## 2.12 Station Electrical Systems

The information in this section of the reference ABWR DCD, including all subsections, figures and tables, is incorporated by reference with the following departures.

STD DEP T1 2.12-2 (Figure 2.12.15)

Figure 2.12.15 Instrument and Control Power Supply

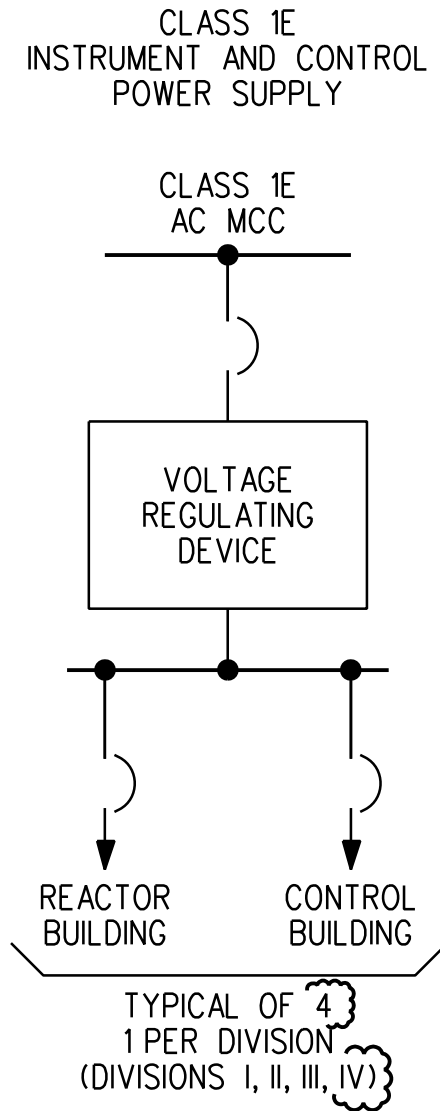
The Class 1E Instrument and Control Power Supply consists of ~~three~~ four divisions (Division I, II, ~~and III, and IV~~) of interruptible power supplies with their respective distribution panels. Each Class 1E power supply provides interruptible, regulated AC power to Class 1E circuits which do not require continuity of power during a loss of preferred power (LOPP).
